165 Williamsons Road, South Morang Transport Impact Assessment

250340TIA001F.docx

9 RESPONSE TO COUNCIL REFERRAL

Figure 11 Peak Hour Traffic Generation – Site Access

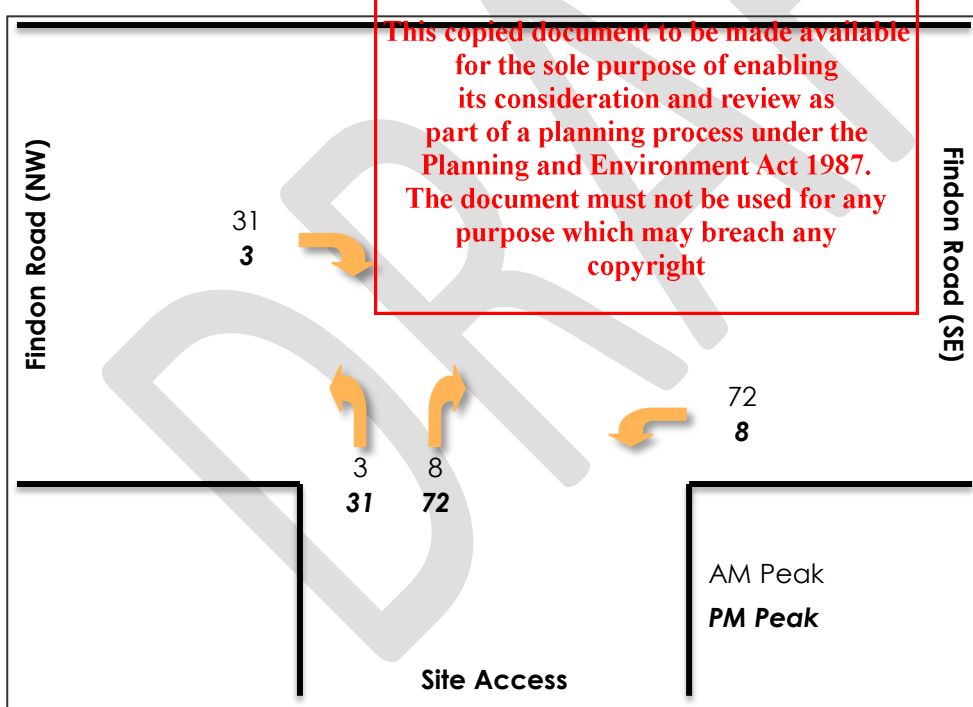
<p>TIA has not been updated as per previous comments. Section 8.1 traffic generation has not clearly indicated the peak number of movements in the AM and PM peak hours as the number (115) does not appear to include the following:</p> <ul style="list-style-type: none"> - Number of deliveries expected and the times. - Traffic demand for the substation/tanks & fuel area. - Does not clearly indicate if there will be an overlap of shifts leading to a higher number of movements at a given time (ie. AM shift end at the same time as PM shift start leading to 230 movements at the PM peak). 	<p>The site is proposed to be provided with full length lanes in the interim and ultimate road network and traffic volumes anticipated to be generated by the development are low in traffic engineering terms.</p> <p>Deliveries are generally not expected to occur during road network peak times, and if they do, numbers will be low. As such deliveries are not expected to have any discernible effect on road network operations. This is also true of the substation and fuel area.</p> <p>Further details around staff shifts have been added to Section 3.1 of this report. As noted, it is not proposed to have back to back shifts that would result in an overlap of employees on the site. Core works hours will be in line with typical business hours, meaning staff arrive in the morning and leave in the evening. Some shift employees may be on-site only certain days of the week but not others, and there may be some overnight security staff who work shifts, but these movements considered within the directional splits included in the traffic assessment.</p>

Drawing Title 165 WILLIAMSONS ROAD, SOUTH MORANG SITE ACCESS - FULL CHANNELISED TURN LANES CONCEPT LAYOUT PLAN - INTERIM		
Designed JPB	Approved SV	Melway Ref 183 D9
Drawing Number 250340	CLP200	Revision D

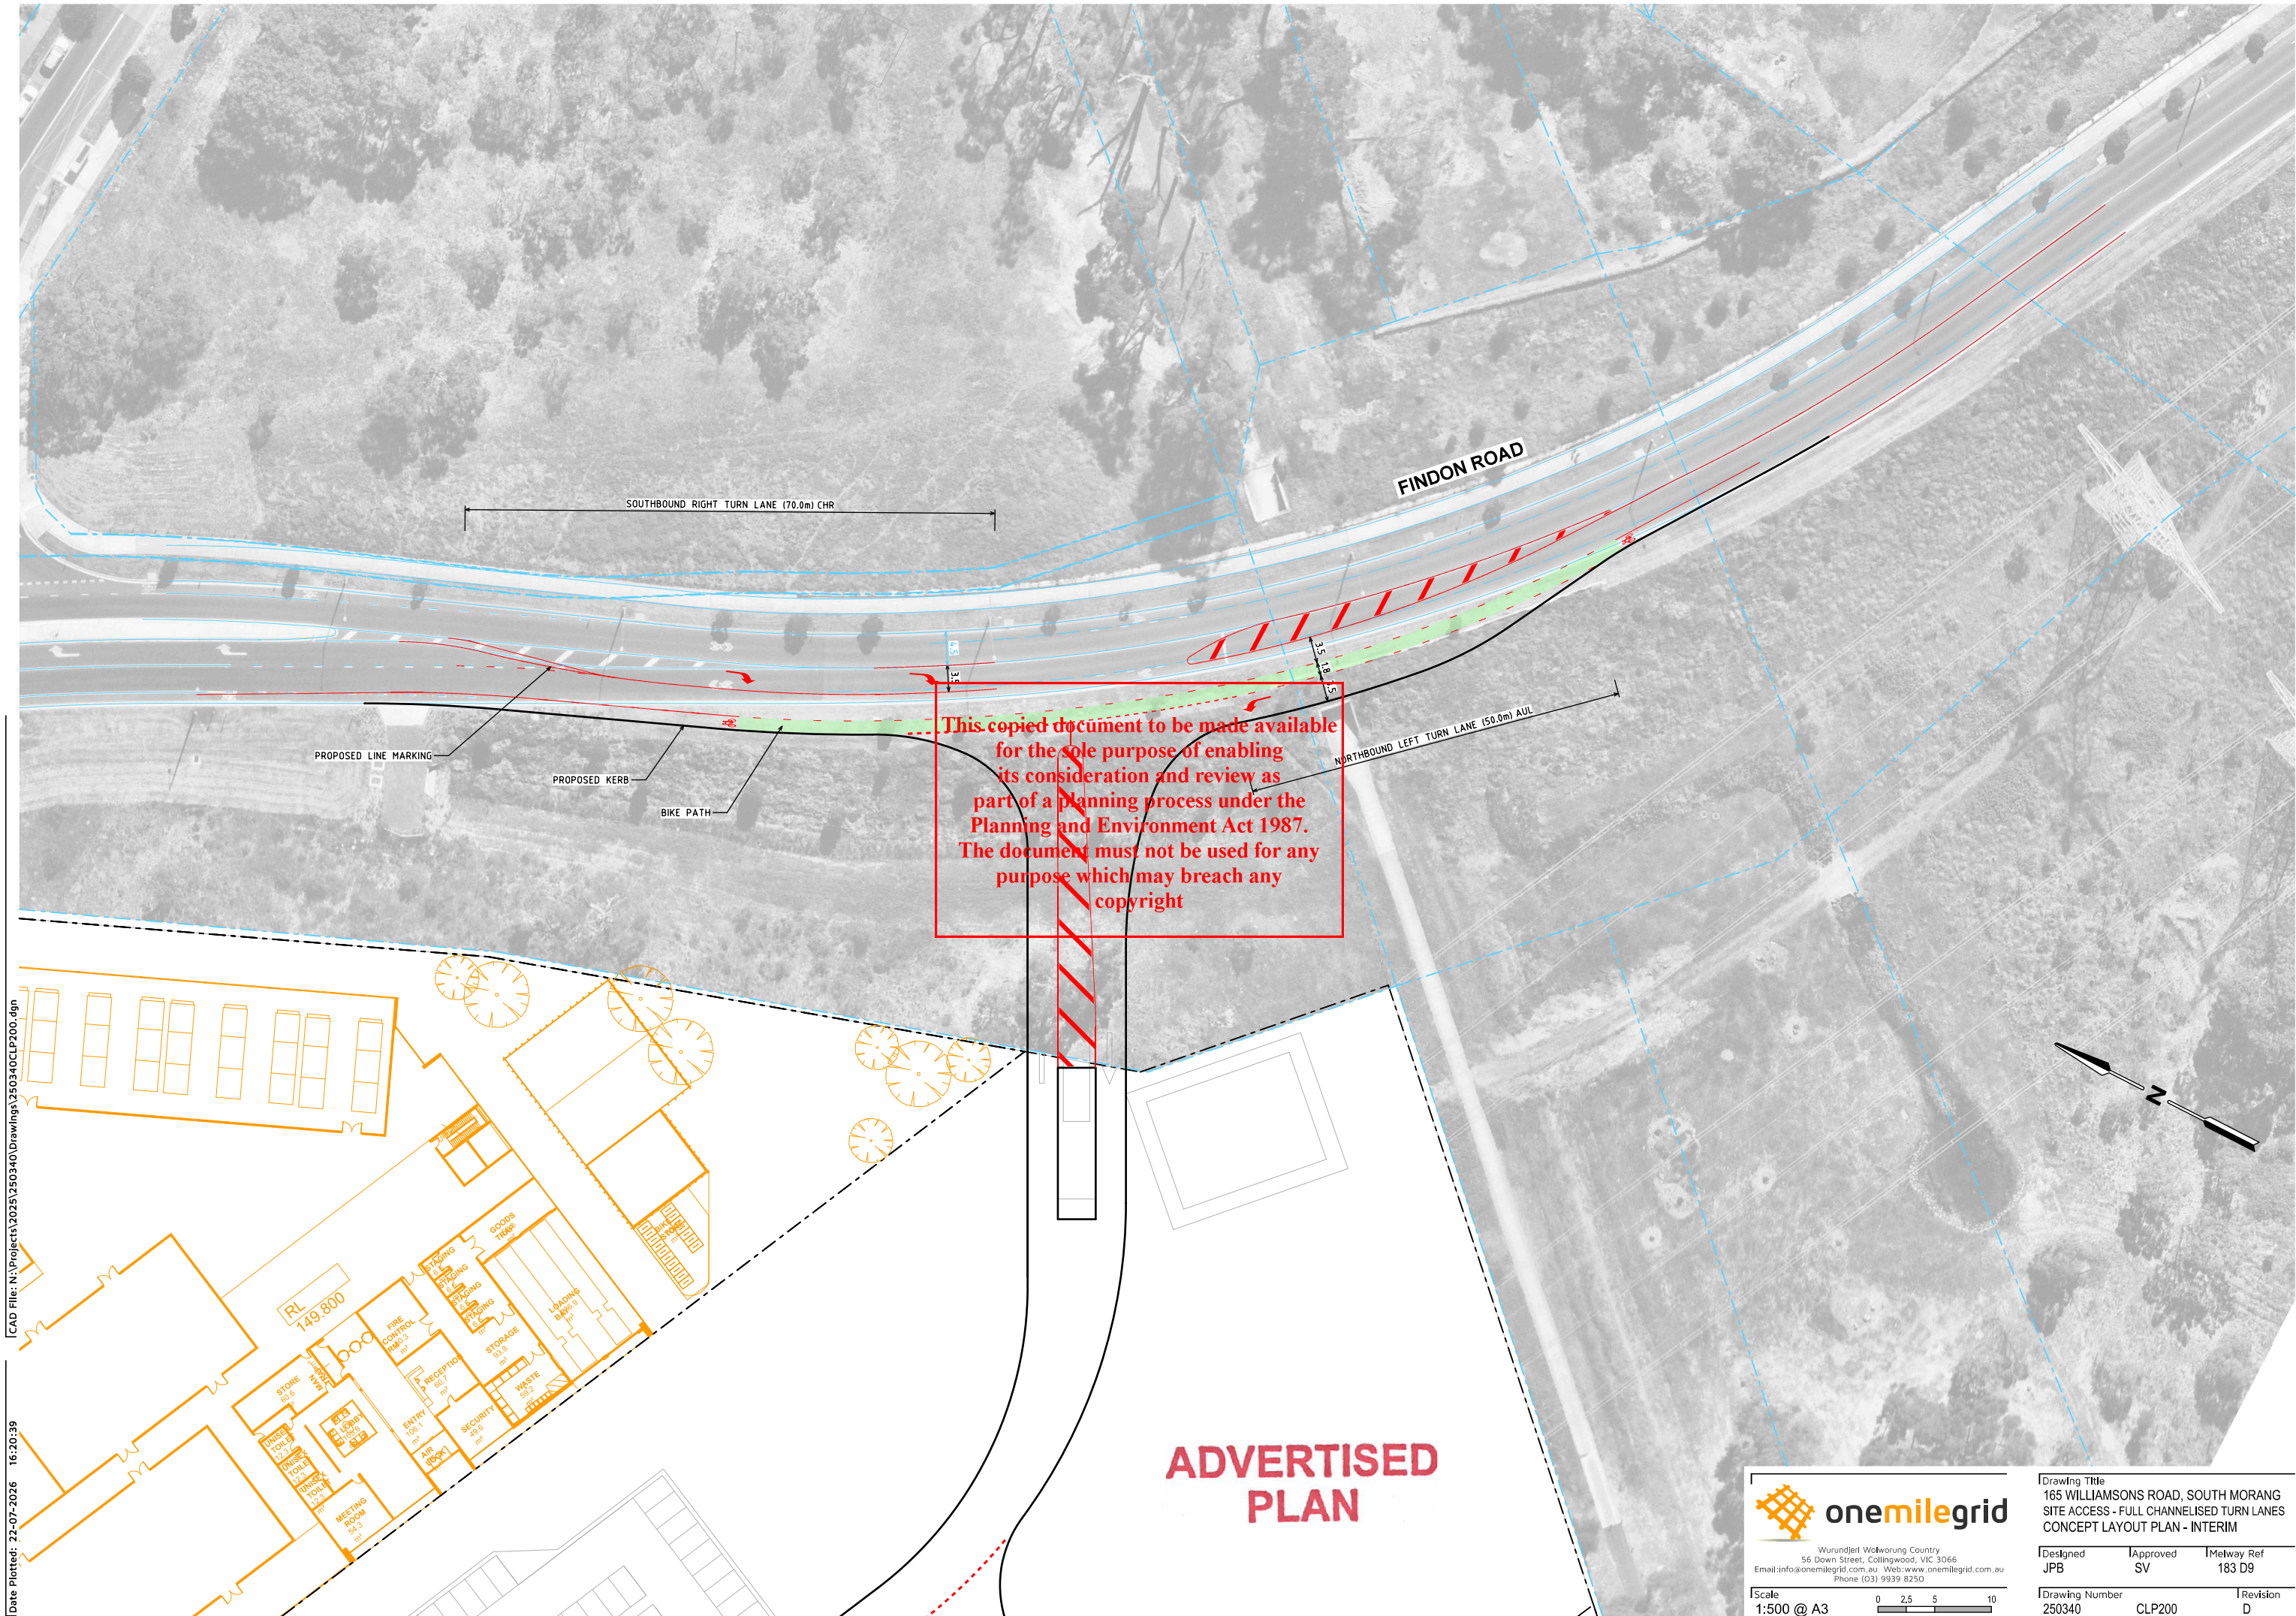
The concept design for the interim arrangement is satisfactory (subject to swept paths being provided with the updated design) however, the cyclist lanes have been incorrectly shown as 1.5m. Widths to be amended to 1.8m as is required.	The concept layout plan for the interim access treatment has been updated to show 1.8 m wide bicycle lanes. A swept path assessment is included.

Drawing Title 165 WILLIAMSONS ROAD, SOUTH MORANG SITE ACCESS - FULL CHANNELISED TURN LANES CONCEPT LAYOUT PLAN - ULTIMATE		
Designed JPB	Approved SV	Melway Ref 183 D9
Drawing Number 250340	CLP300	Revision A

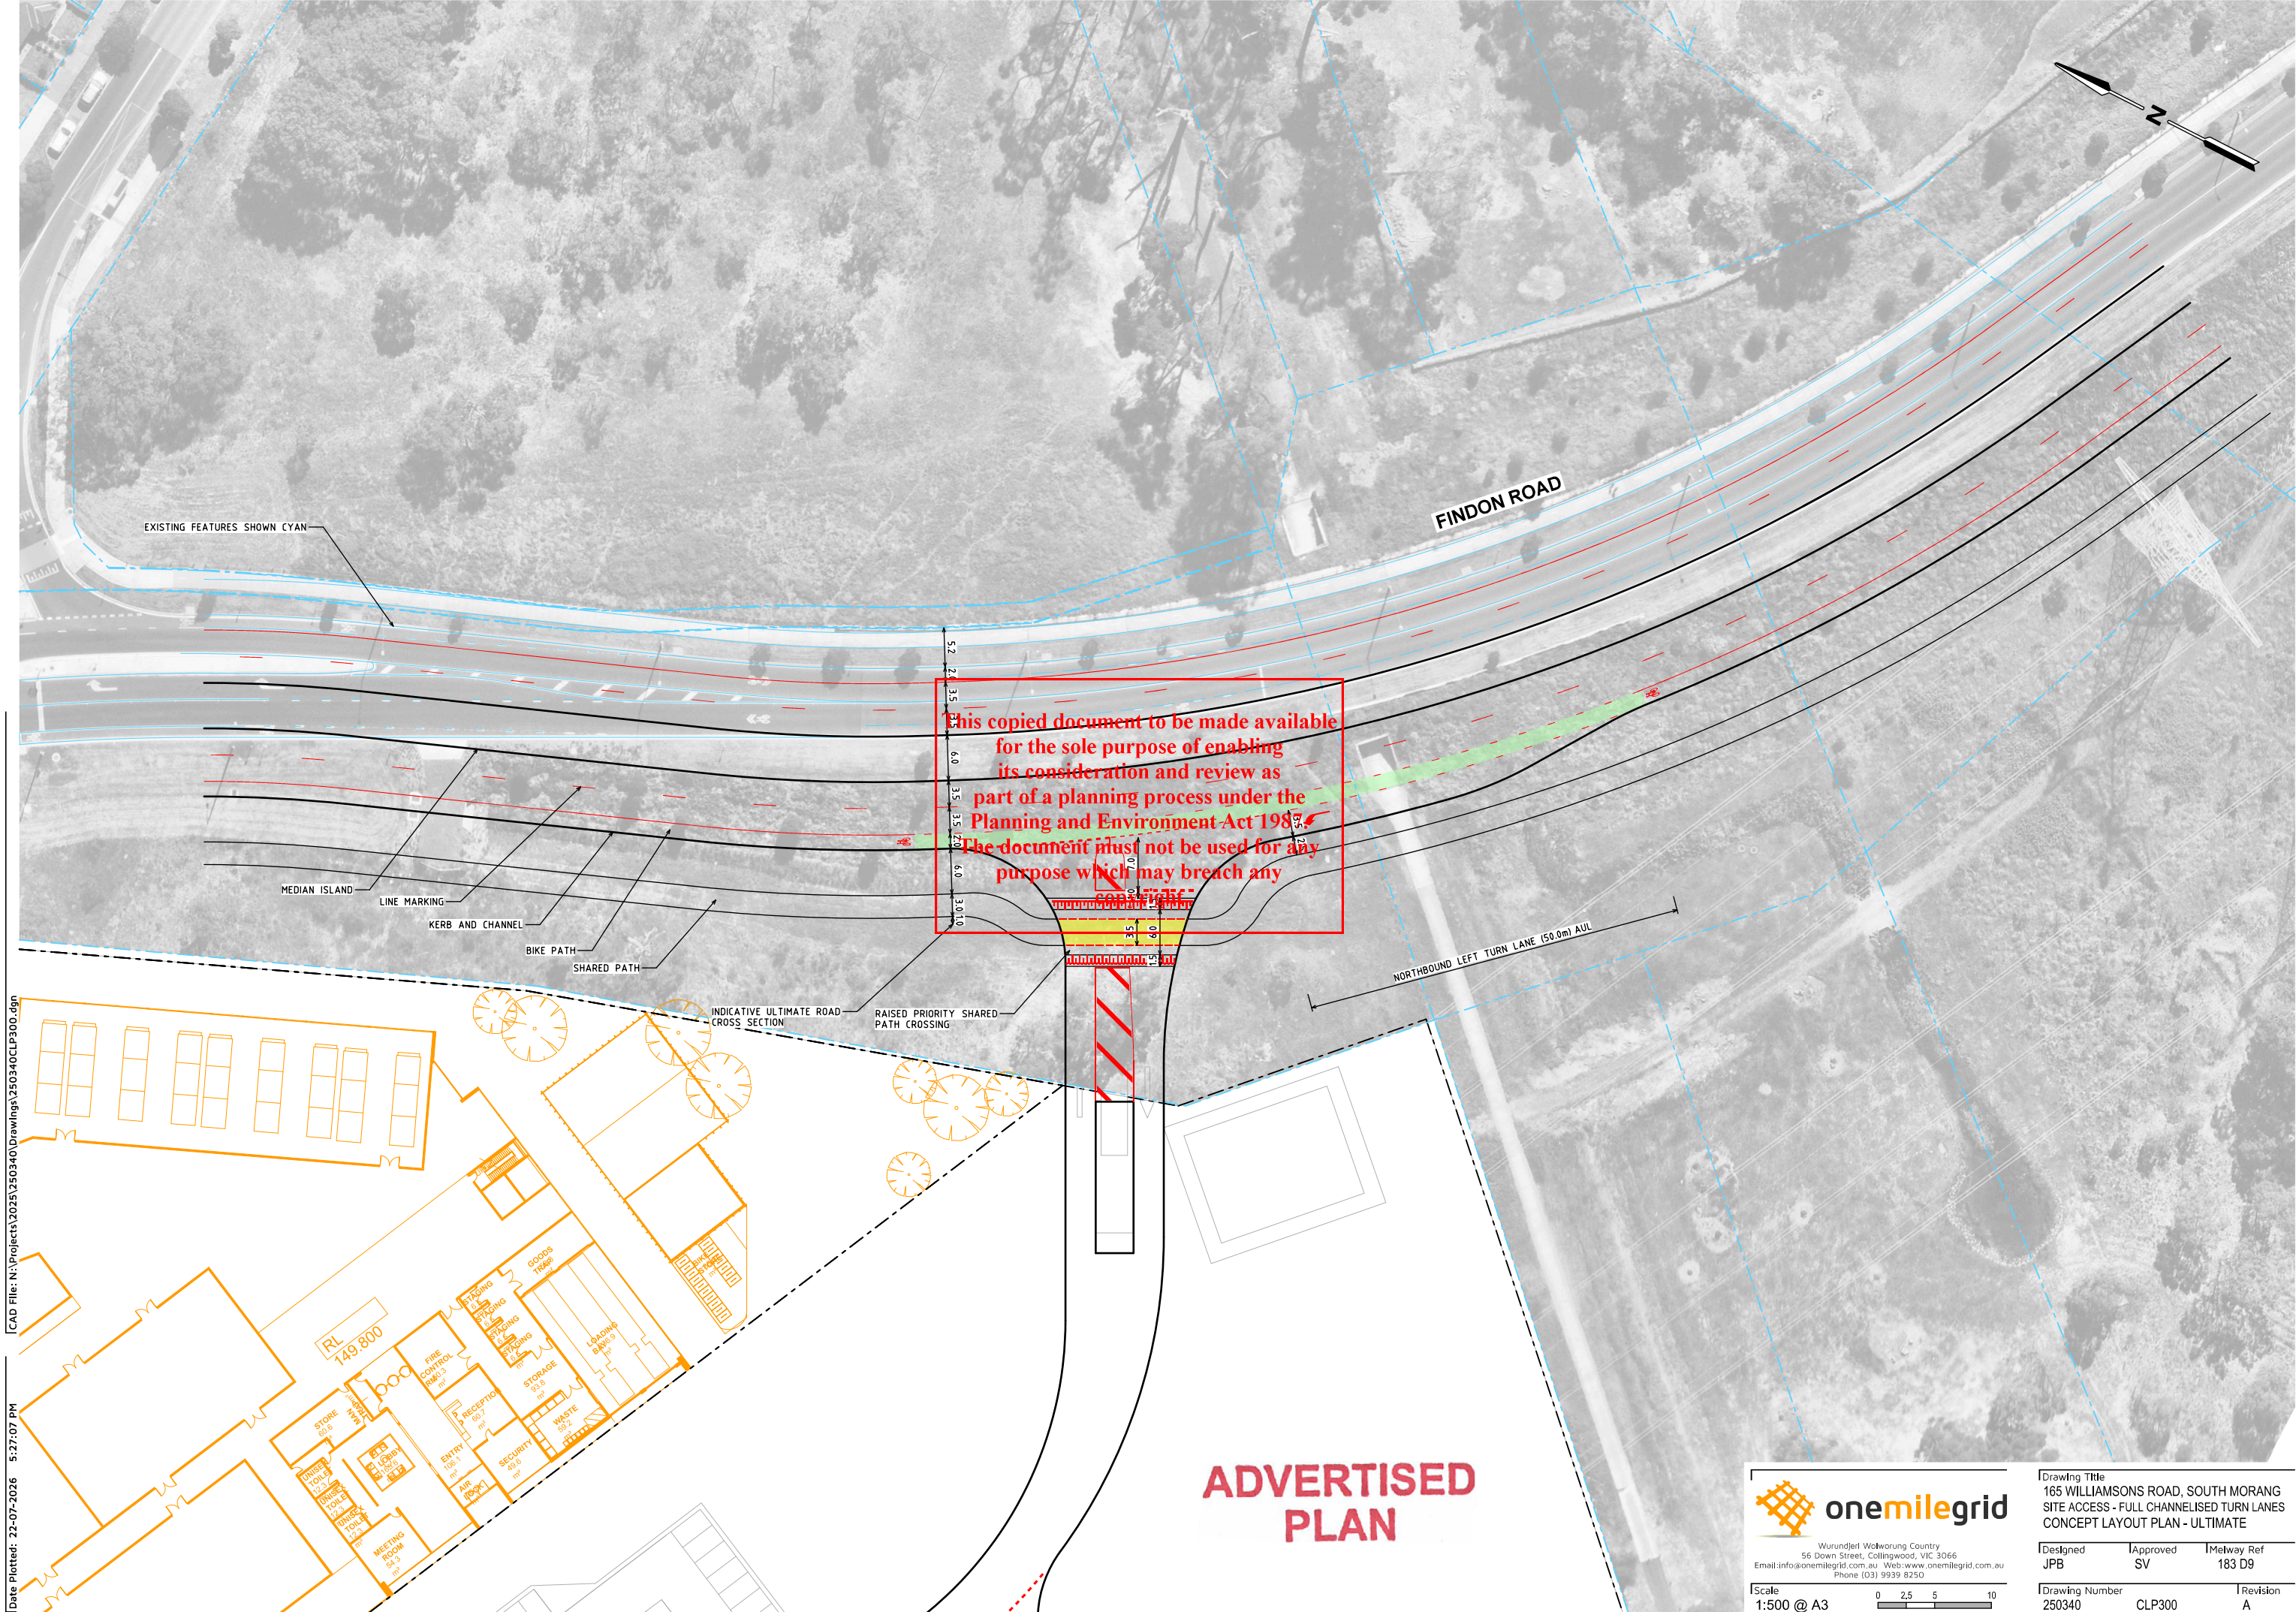
Comment	Response
Design	
As access via Williamsons Road is not being proposed, the approval of this development will likely prevent any connection via the existing road reserve and the intersection being constructed to a 4 leg ultimately. However, the proposed design does work in the interim and ultimate (duplicated road reserve) scenarios.	<p>The proposed development does not affect the road reserve that runs along the northern boundary of the site. As such it is not clear how approval of the development would preclude any external road network alterations, unless those external road works were reliant on acquiring land from the subject site.</p> <p>As noted, suitable access for the subject site is proposed from Findon Road.</p>
<p>A separate plan showing the indicative ultimate road reserve is to be provided to show that the access will function in both scenarios. Additionally, the ultimate scenario will have a path on both sides, this is to be shown and how it integrates with the site.</p>	<p>A concept layout plans (CLP300) has been prepared to demonstrate how the site access could integrate with the ultimate duplicated configuration of Findon Road. This plan is enclosed in Appendix C.</p> <p>It is understood that design decisions around the ultimate design of the Findon Road duplication are yet to be made. As such the concept layout plan adopts a typical 4 lane arterial road cross-section that would work within the available road reserve both at the site frontage and elsewhere along the road corridor.</p> <p>The concept plan shows that the site access could revert to a left in / left out arrangement with a left turn deceleration lane to accommodate the entry movement, while still allowing for on-road bicycle lanes and an off-road shared user path with a raised priority crossing. It should also be recognised that there is ample spare space within the road reserve at the site frontage should there need to be variations on this design.</p>
